Product Change Notification - SYST-08WVEY132

ERRATA - SAM G55 Series Family Silicon Errata and Data Sheet Clarifications

SAM G55 Series Family Silicon Errata and Data Sheet Clarification

Data Sheet Clarifications

8. Module: USART - Transmitter Operations

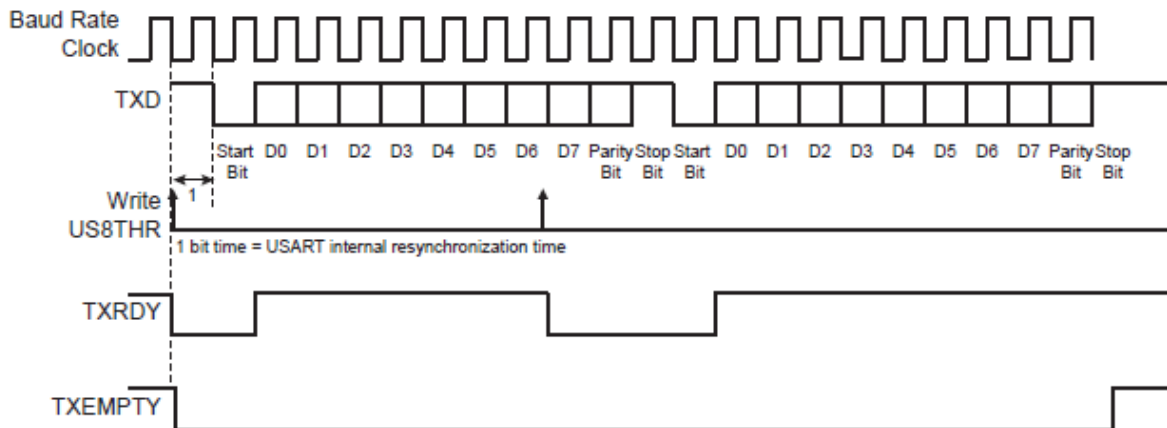
Figure 30-6 is incorrect. The corrected figure is as shown below:
